VIRGINIA ELECTRIC AND POWER COMPANY
RICHMOND, VIRGINIA 23261

VIRGINIA ELECTRIC AND POWER COMPANY
NORTH ANNA POWER STATION UNITS 1 AND 2
PROPOSED TECHNICAL SPECIFICATION CHANGES
IMPLEMENTATION OF ALTERNATE SOURCE TERM

DISCUSSION OF CHANGE
PROPOSED ALTERNATE SOURCE TERM LICENSE AMENDMENT

Figure 3.1-1

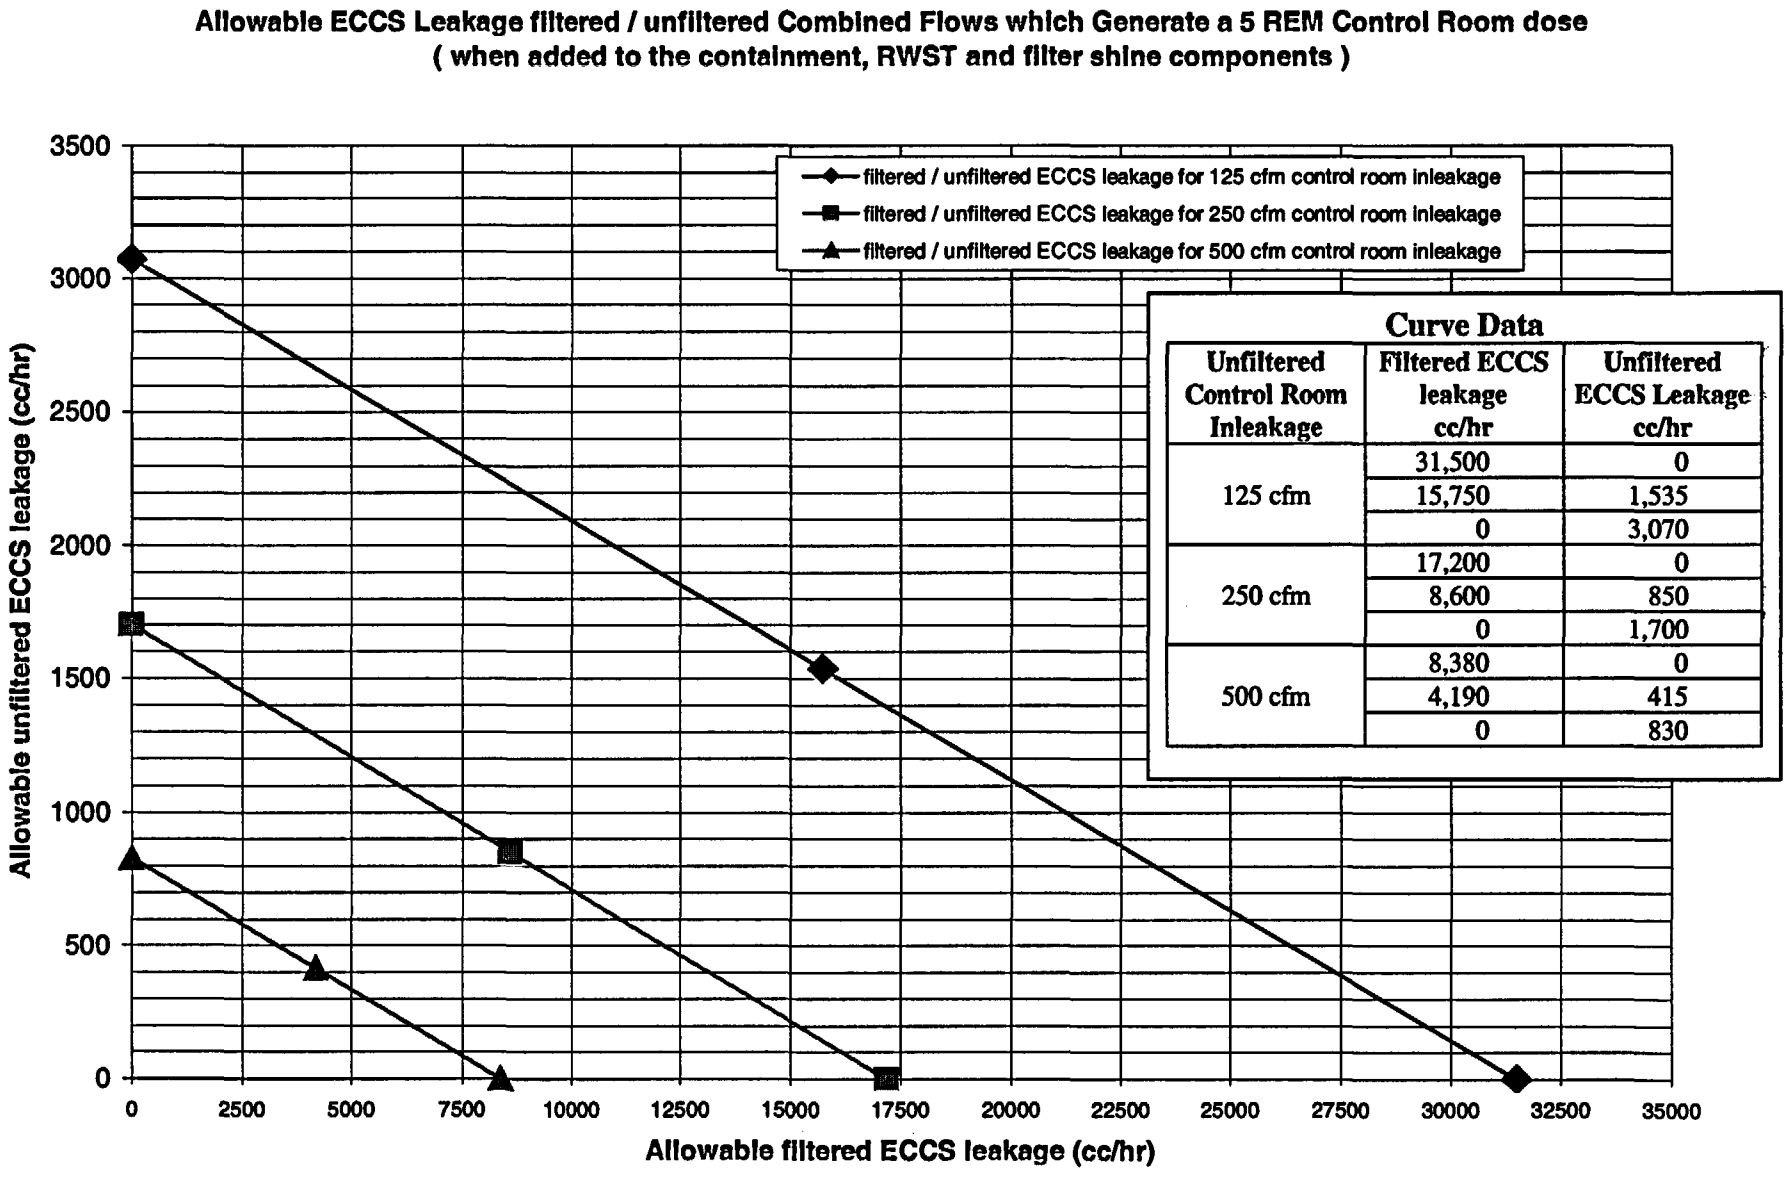
a. Change the applicability of LCO 3.7.12, "Emergency Core Cooling System (ECCS) Pump Room Exhaust Air Cleanup System (PREACS)," to indicate that the LCO will be applicable according to Specification 5.5.2. A new section, 5.5.2.c, is added to the Specification to develop an ECCS leakage curve that defines PREACS (LCO 3.7.12) applicability during Modes 1 through 4.

A change is proposed to the applicability of LCO 3.7.12 to indicate that the LCO will be applicable according to Specification 5.5.2. A new section, 5.5.2.c, is added to the Specification to develop an ECCS leakage curve that defines PREACS (LCO 3.7.12) applicability during Modes 1 through 4. This curve is intended to represent a set of conditions, including ECCS leakage, MCR inleakage, RWST leakage, etc., that meet the control room dose limits (5 Rem TEDE). It is anticipated that this curve will be revised under 10 CFR 50.59 to address changing operating conditions for ECCS leakage, MCR inleakage, RWST leakage, etc.

RADTRAD-NAI runs were made with combinations of filtered and unfiltered ECCS leakage rates that resulted in total control room doses of 5 rem TEDE when added to doses from containment leakage, RWST leakage, and filter shine. The results of these runs are presented below in graphical form in Figure 3.1-1.
